**NETWORK RAIL (STALYBRIDGE TO DIGGLE  
(SADDLEWORTH) ENHANCEMENTS) ORDER**

**REBUTTAL PROOF  
RELATING TO PROOF OF EVIDENCE OF JOHN WALTON  
(OBJ/260) SUBMITTED ON BEHALF OF THE RAMBLERS  
ASSOCIATION**

| Document Reference | <b>NR/PoE/REB/OBJ/260</b> |

Figure 2 View of MVL3/10a Site Location

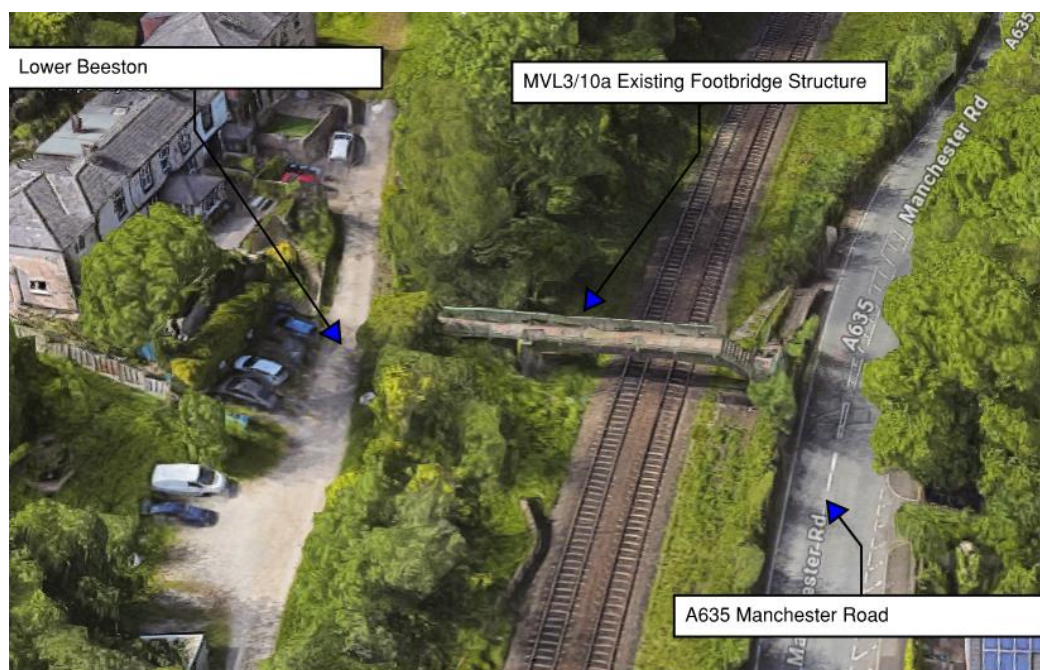
2.2.6 At optioneering stage for MVL3/10a it was recognised at vehicular access to the site was good due to the proximity of Manchester Road and Lower Beeston. See Figure 2.

2.2.8 MVL3/10a is like the 2022 Footbridge considered at Moorgate Level Crossing in that new foundations are required for a footbridge. However, the proximity of the adjacent roads significantly simplifies the design and construction of the foundations at MVL3/10a in comparison to the 2022 Footbridge.

- 2.2.14 To build a footbridge at Moorgate Halt requires all materials and plant to be delivered via the railway and all activities, including foundations and bridge installation, completed during closure of the railway.

- 2.2.15 Therefore, in my opinion, the engineering and design constraints associated with MVL3/10a and those relating to the 2022 Moorgate Footbridge proposal are not reasonably comparable.

Figure 6 Extract from Appendix 8A.1

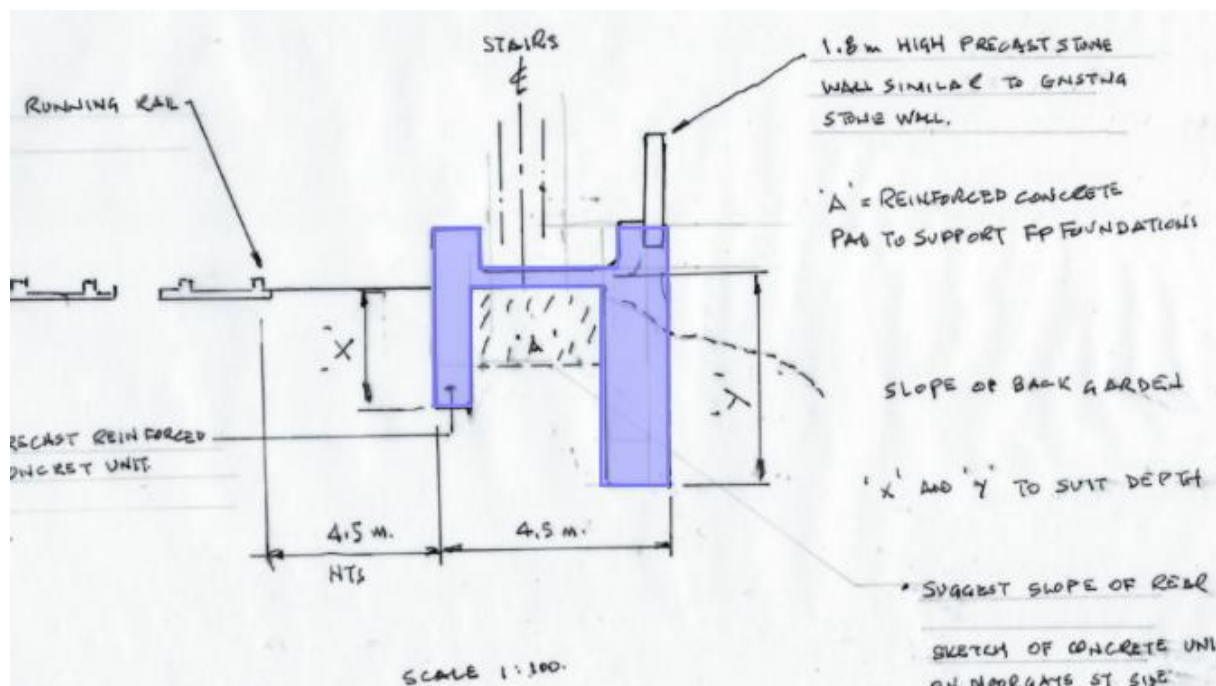
2.2.35 The sketch provided for the alternative east support is not to scale or informed by a topographic survey.

2.2.36 I reference [NR/PoE/LB/11.9] which shows the proposed alternative on elevation 'Ramblers Association OBJ 260 Alternative solution Elevation' to scale with the topographic survey.

2.2.37 The spread foundations specified for a footbridge would not be adequate at this location. Ground investigation at this location has identified that the structure would need to be piled due to made ground.

2.2.38 The retaining walls either side of the pad foundation (see figure 1, blue outline) do not represent a recognised engineering solution for retention. It does not appear to be a spread foundation or piled.

2.2.39 In my opinion the proposed engineering solution does not account for the poor ground condition and location partially down a slope.
